CHANGE ORDER: 368
INSTRUCTION BULLETIN: DEFERRED APPROVAL (DDENUM)

PROJECT NAME
CHILDREN'S HOSPITAL OF ORANGE COUNTY
455 S. Main St.
Orange, CA 92668-3874

DRAWING TITLE
LEVEL 1 ENLARGED PLAN AREA - U

DRAWING NUMBER
A3.1U

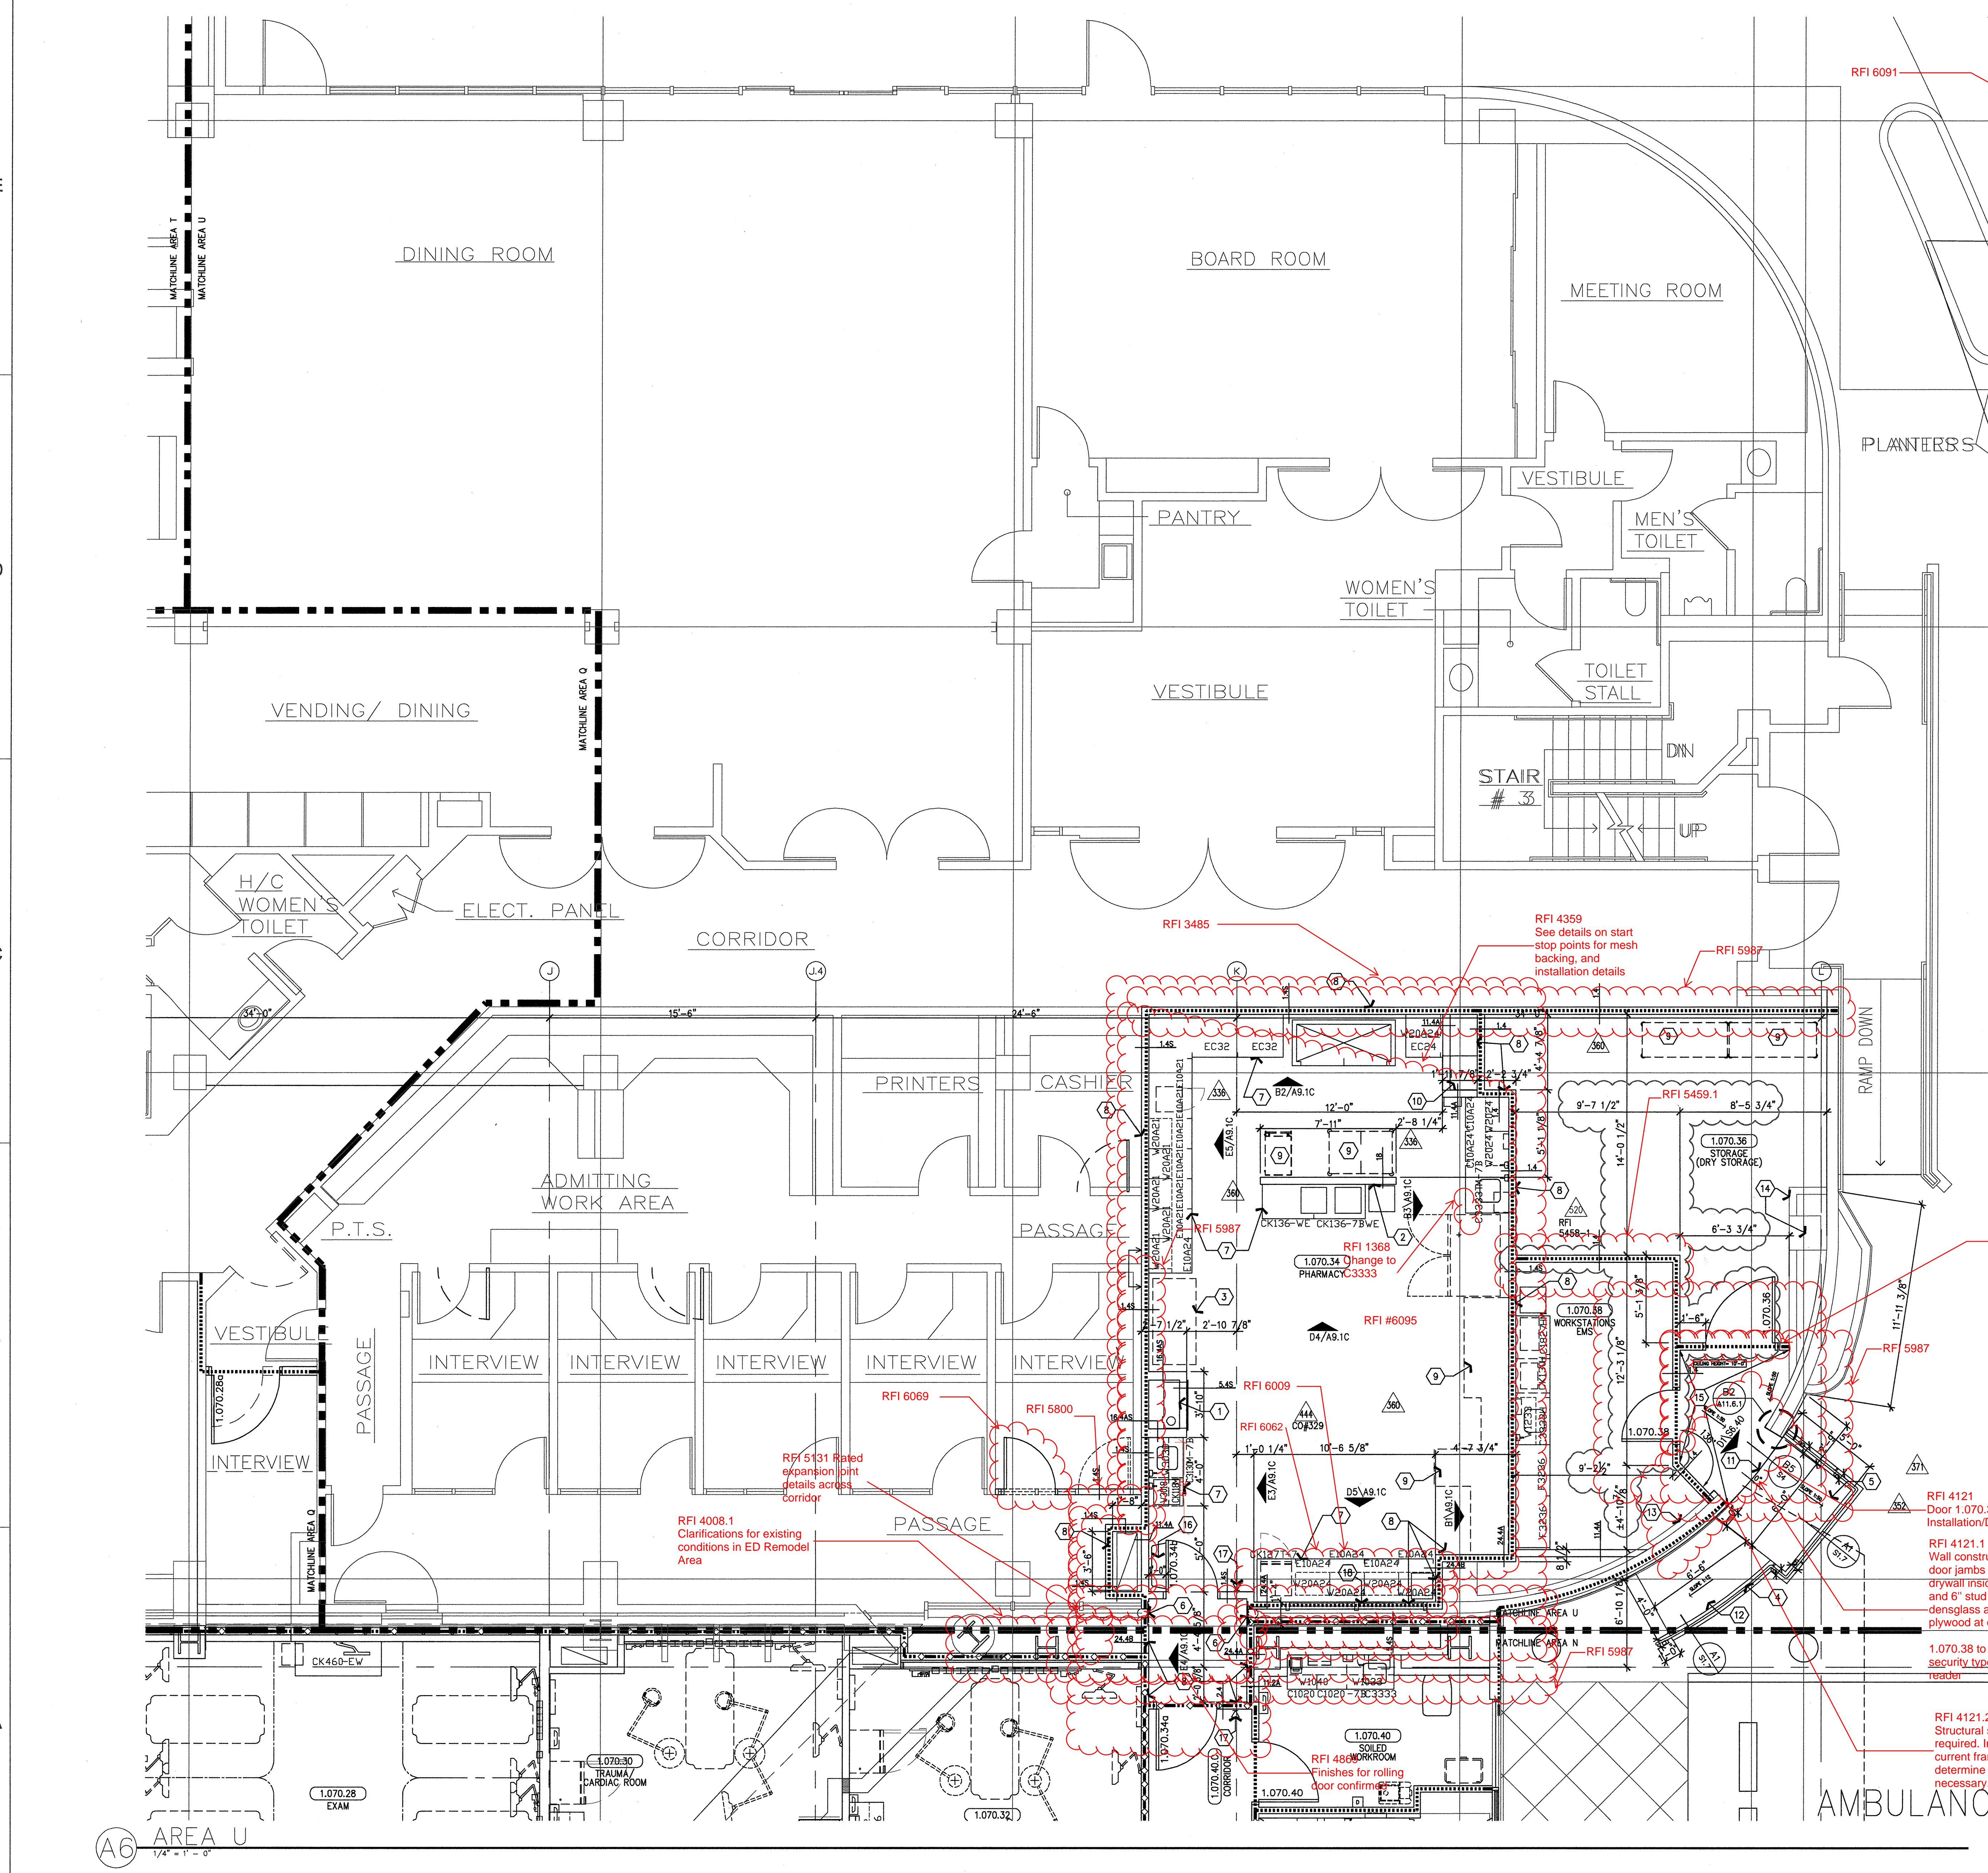
- RFI 4121 Door 1.070.38 & 1.070.36 Installation/Details
- RFI 4121.1 Wall construction at door jambs will be 5/8" drywall inside rooms and 6" stud + 5/8" demglass and plywood at exterior.
- 1.070.38 to receive security type 3 w/card reader
- RFI 4121.2 Structural support required. Investigate current framing, and determine what is necessary.
